ADDENDUM NO. 3

August 7, 2026

MERRILLVILLE HS CULINARY AND MEETING AREA RENOVATIONS AND MERRILLVILLE CSC CENTRAL OFFICE ADDITION AND RENOVATION PROJECT

This Addendum consists of pages ADD 3-1 through ADD 3-2 and attached Addendum No. 3 from Gibraltar Design dated August 6, 2026, and consisting of 5 pages, Specification Section 10 11 00 - Markerboards and Corkboards, Specification Section 28 13 00 - Access Control System, and 22 Drawings.

1
A-130
1\"/>

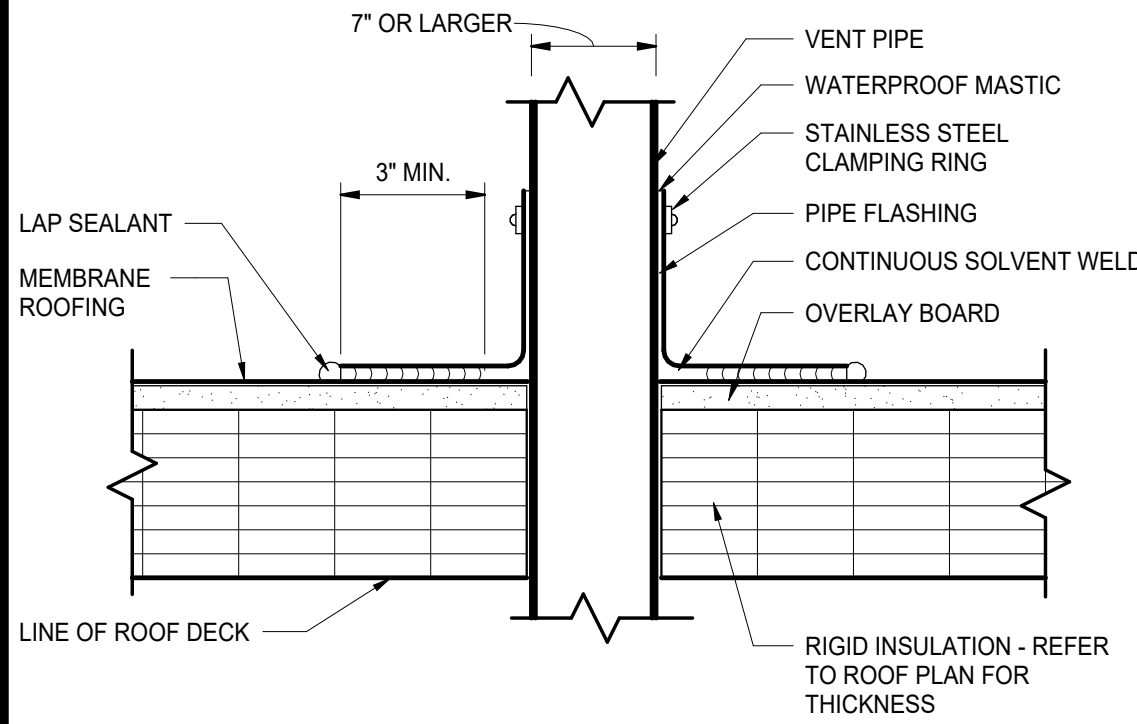
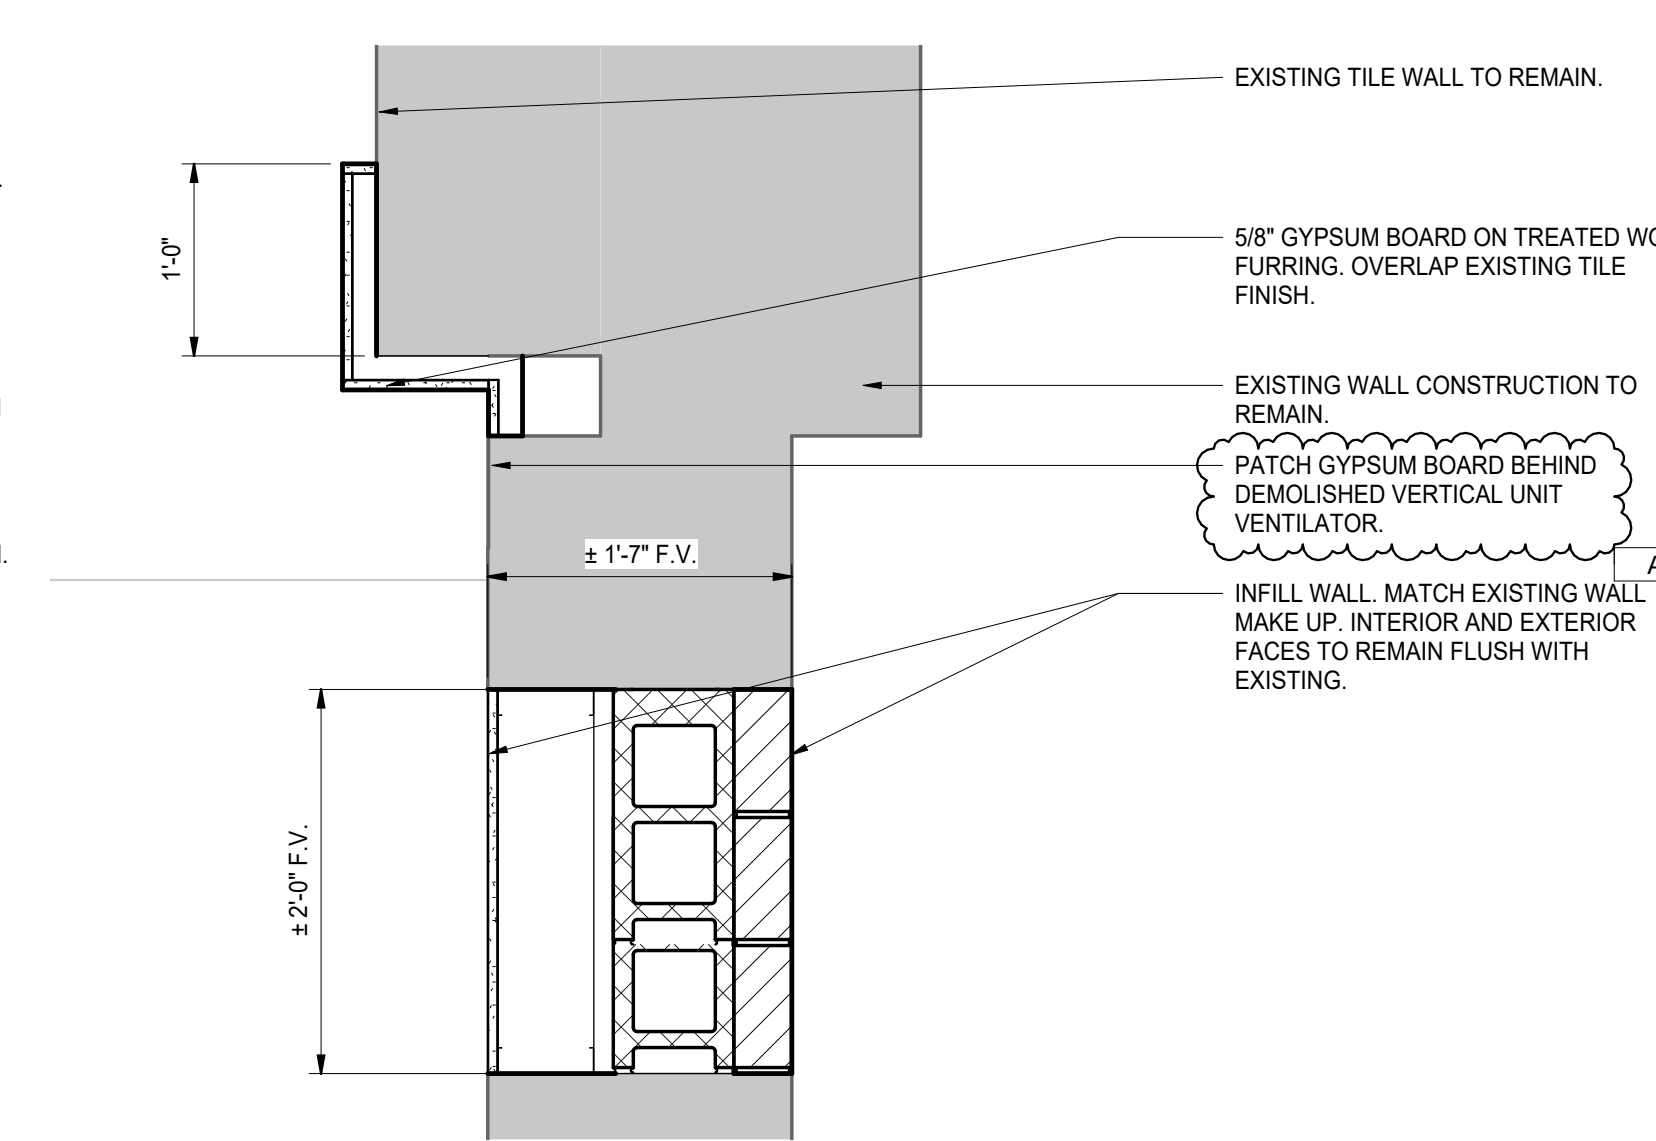
8. Sheet A-130

- A. Refer to revised, full-size drawing, included in this Addendum, for revisions.
 - 1. At detail 1, add note "PATCH GYPSUM BOARD BEHIND DEMOLISHED VERTICAL UNIT VENTILATOR."
 - 2. Noted typical details markings at various details.

UNIT "T" ARCHITECTURAL ROOF PLAN

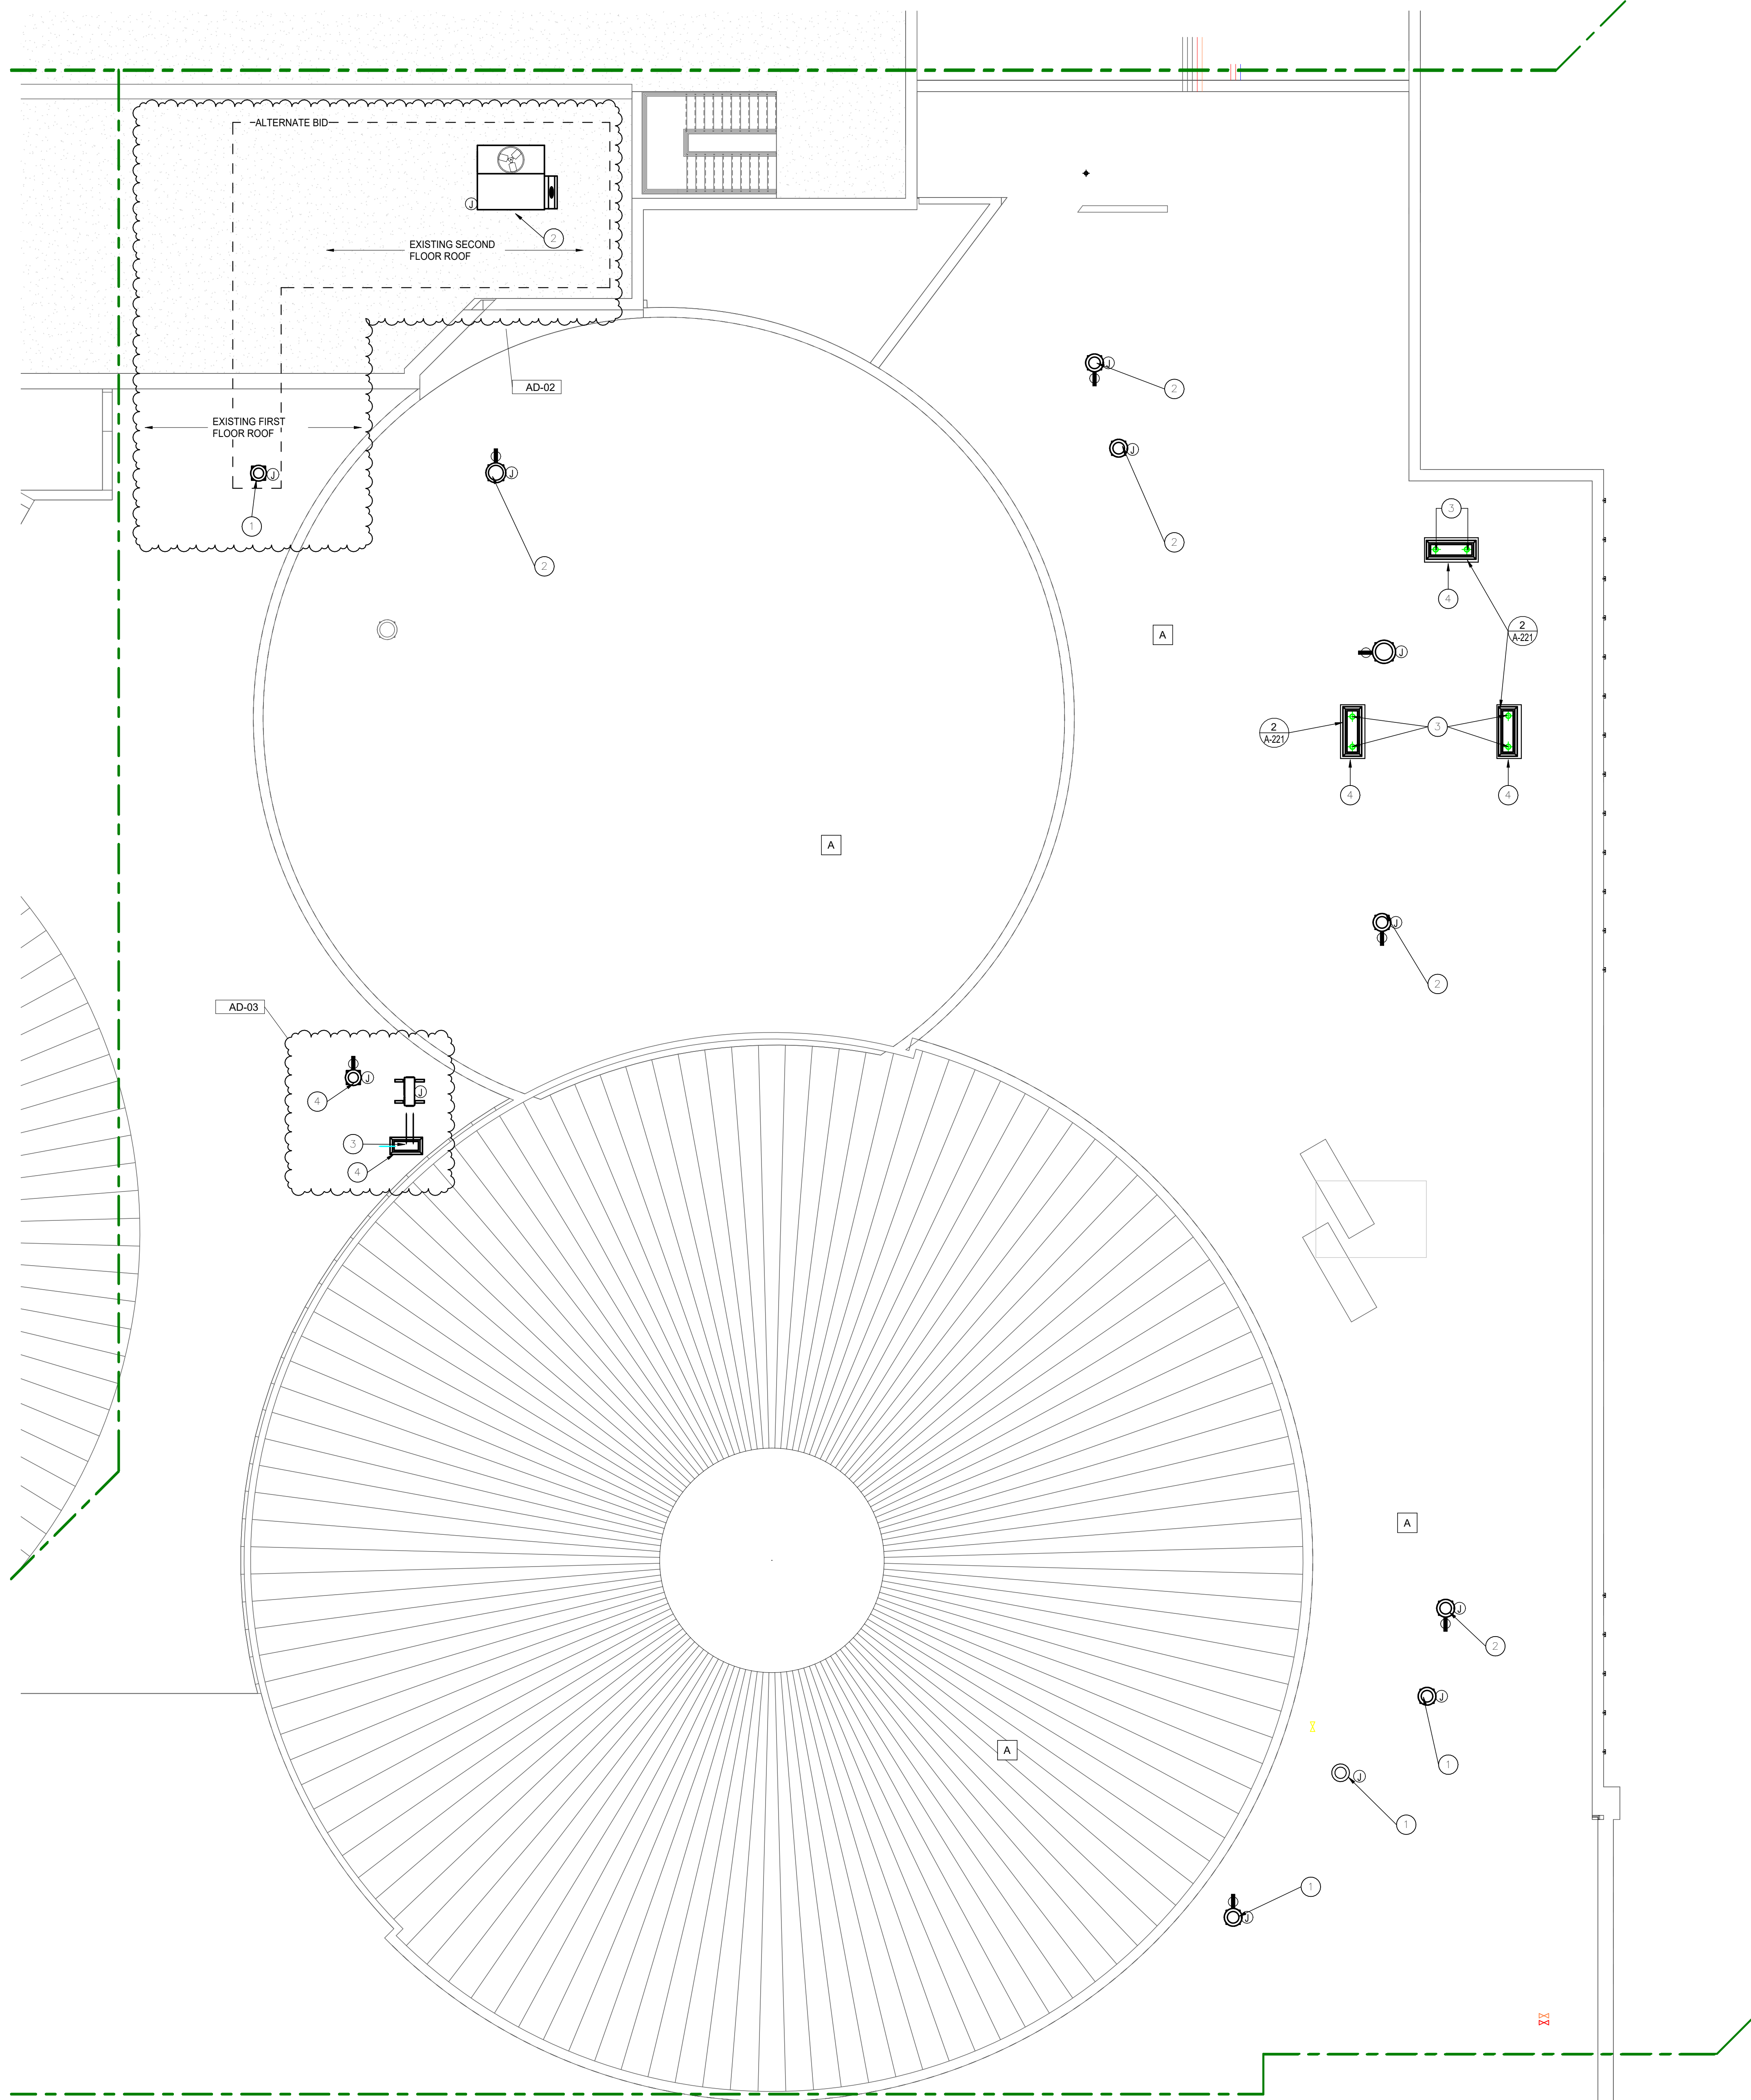
9. Sheet A-221

- A. Refer to revised, full-size drawing, included in this Addendum, for revisions.
 - 1. Added notes and a curb and portal.

DOOR SCHEDULE, FRAME PROFILES, ELEVATIONS AND DETAILS

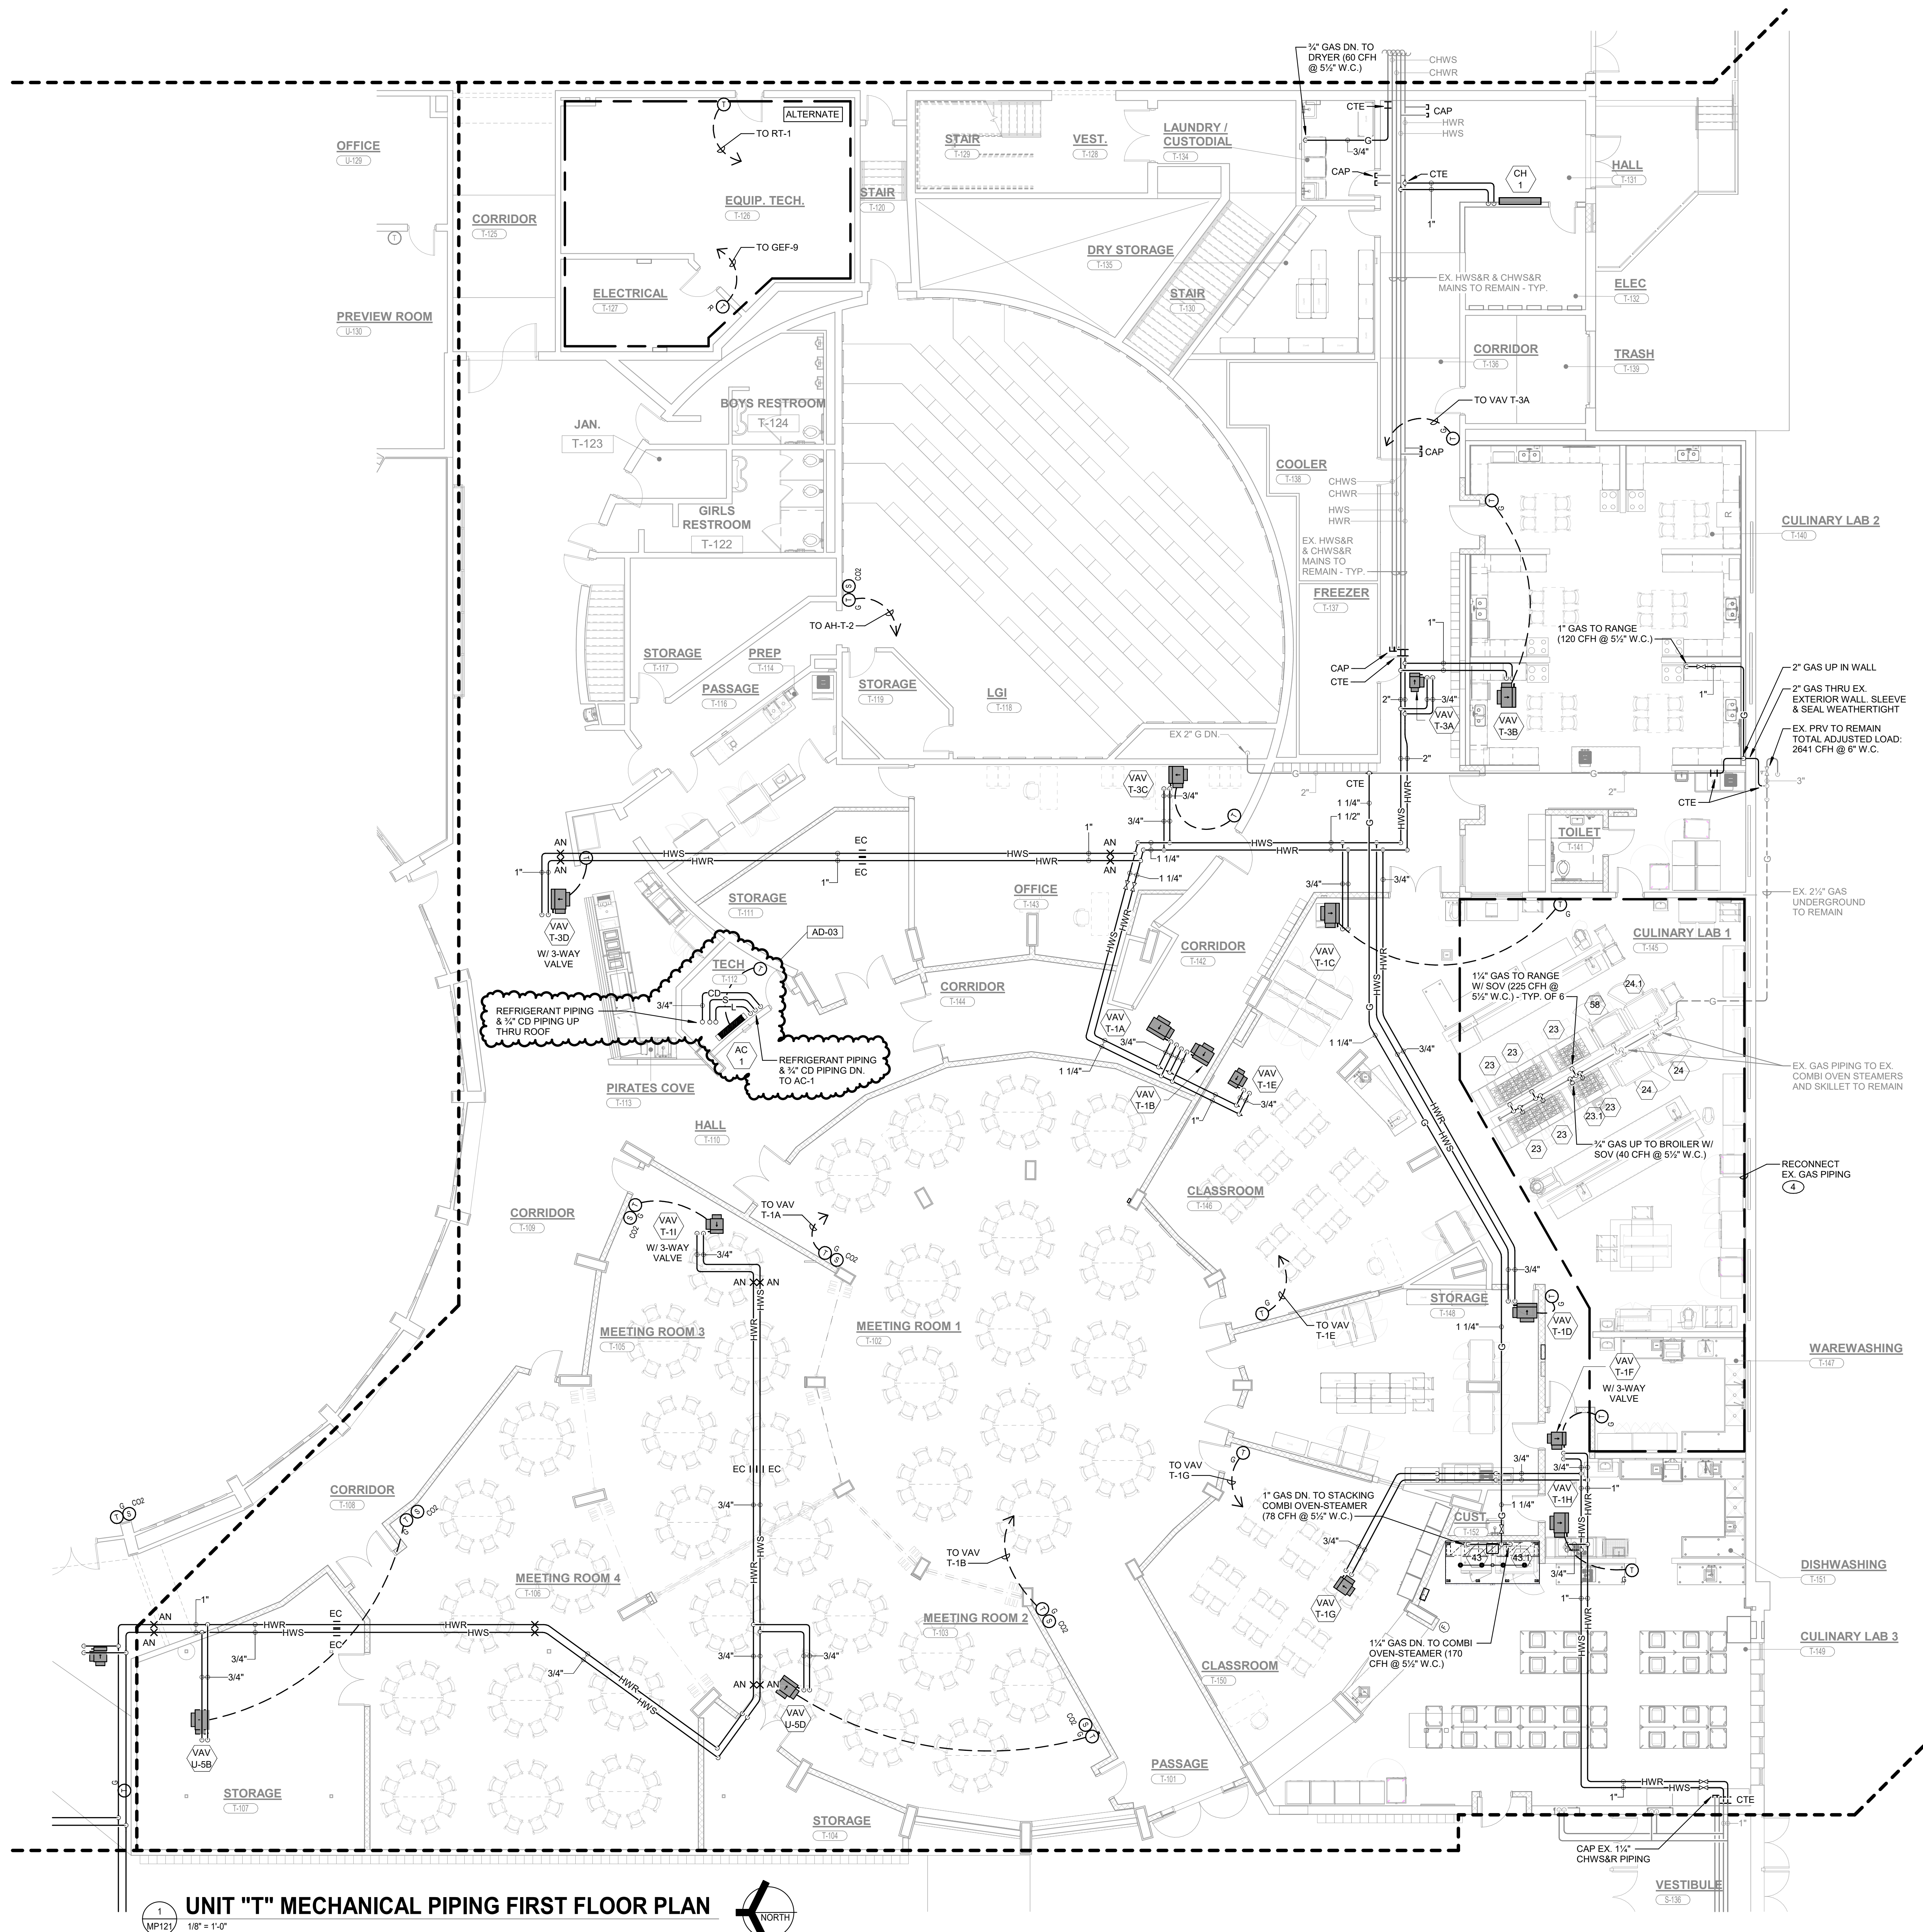
10. Sheet A-601

- A. Refer to revised, full-size drawing, included in this Addendum, for revisions.
- B. Door T-112 is new wood slab in existing frame. Hardware as specified, with reuse of existing hinges.

1
MP121
UNIT "T" MECHANICAL PIPING FIRST FLOOR PLAN
1/8" = 1'-0"

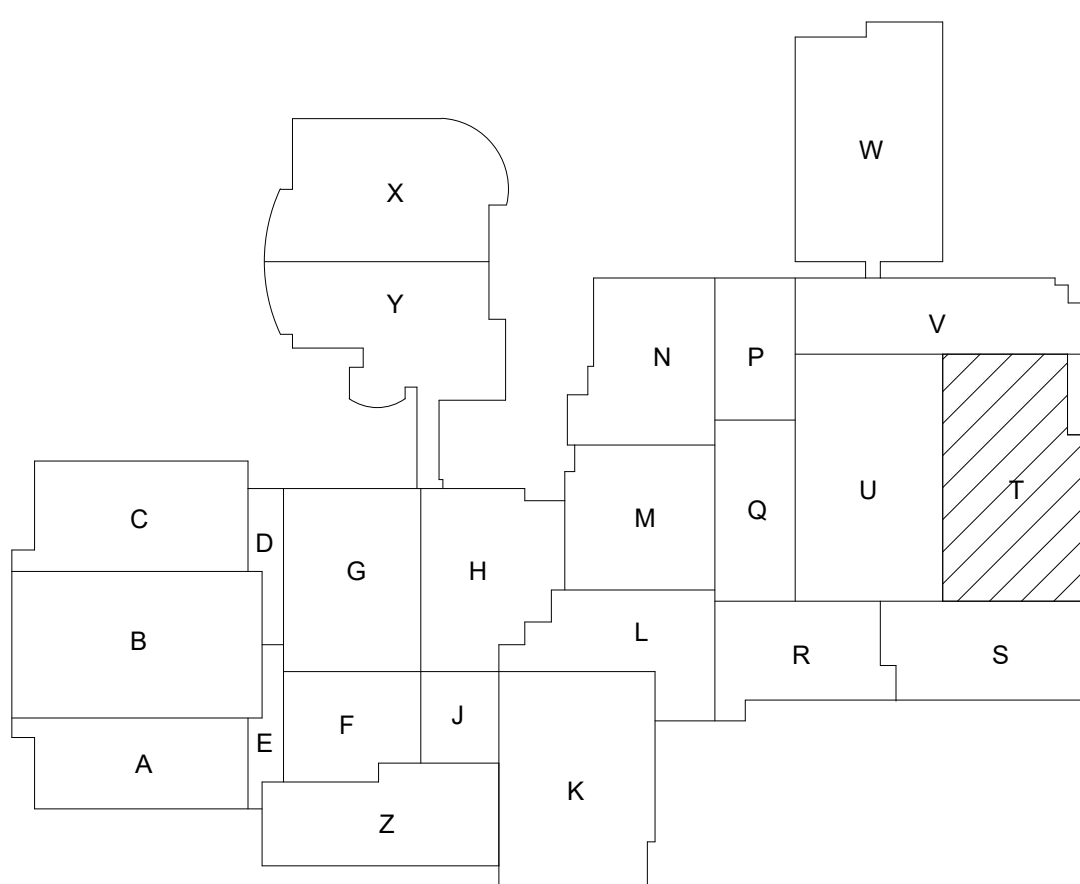
11. Sheet MP121

- A. Refer to revised, full-size drawing, included in this Addendum, for revisions.
 - 1. Added AC-1 to tech room T-112
